1963 - 1967 Corvette: Service News: Corvette Coupe Body Rework for Larger Racing Tires (Rear Wheels)

Subject: Corvette Coupe Body Rework for Larger Racing Tires (Rear Wheels)

Model and Year: 1963 - 1964 Corvette

Date: August 1964, Volume 36, Issue Number 7

Fig. 2—Rework of 1963-64 Corvette Model 837 for Installation of Larger Tires

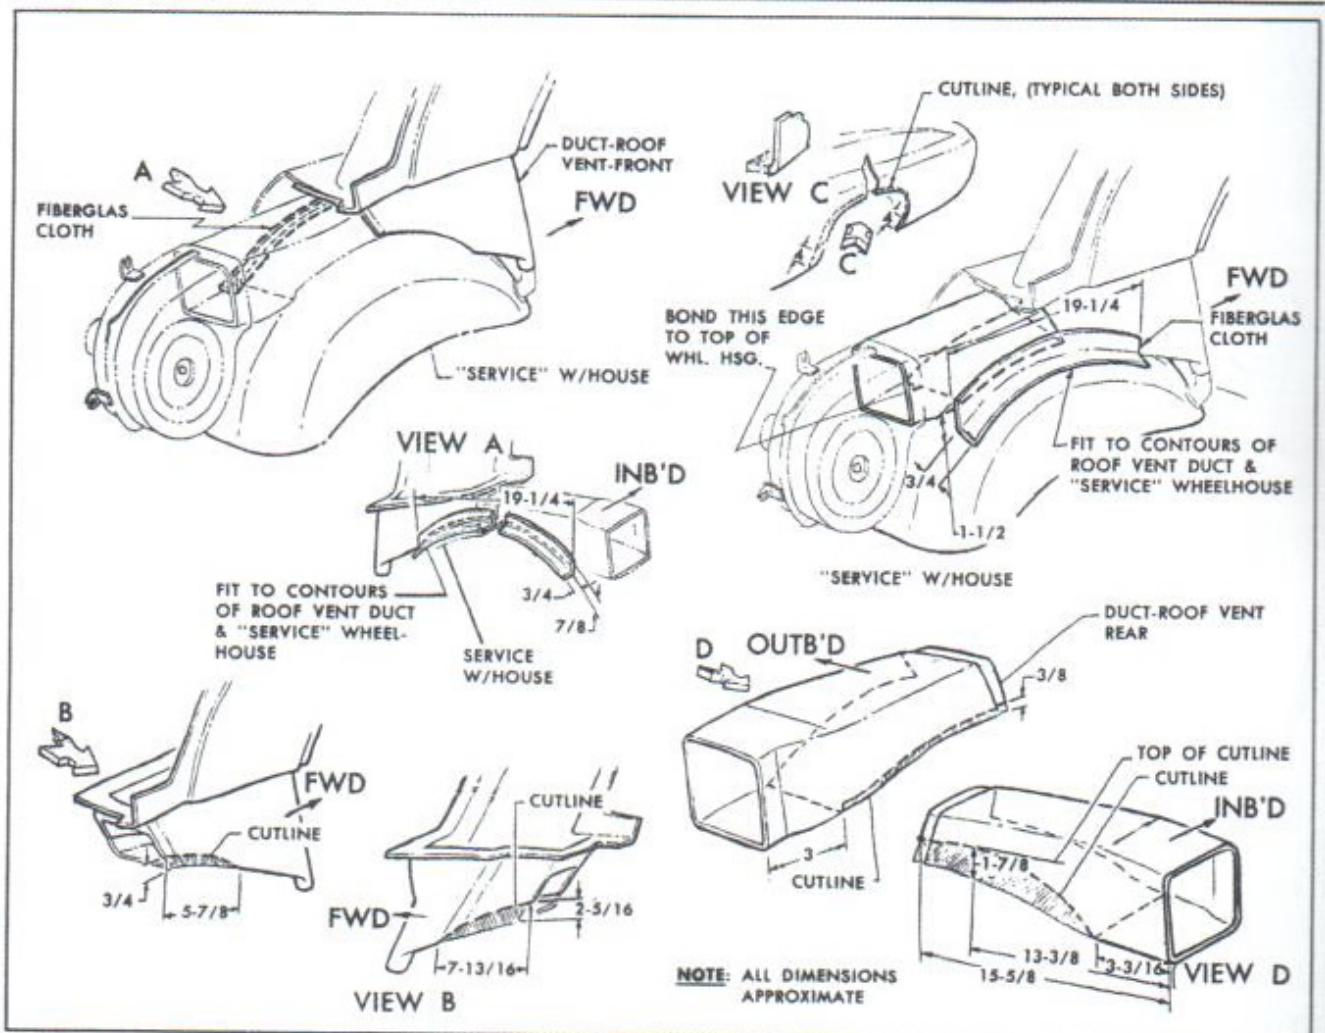
On closed models, adequate wheel travel clearances may be obtained for 7.10-7.60 x 15 tires mounted on RPO P48 Aluminum Knock-off Wheels (6" rim width) by installing the inner wheel housings which are used in Production with the RPO N03 fuel tank of 35 gallon capacity, and by cutting material away in the wheel openings. These wheel housings are serviced under P/N's 3794441 and 3794442 for the right and left sides respectively. On the left side, considerable rework is required to make the larger wheel housings fit under the body rear compartment air exhaust duct. Individual owners may elect to have the exhaust duct system removed instead of going to the expense of the rework. If the rework is undertaken, the efficiency of the rear compartment air exhaust system will be decreased because of the reduced duct area just over the wheel housing.

Refer to Figure 2 for details of the installation of the larger wheel housings, the provision of extra clearance between the tire and wheel openings, and the

modification of the body rear compartment air exhaust duct. In those areas where cutting and rebonding of fiberglass is involved, regular shop practices and materials should be used. The use of the materials show in Group 12,800 of the Chevrolet Parts Catalog is suggested.
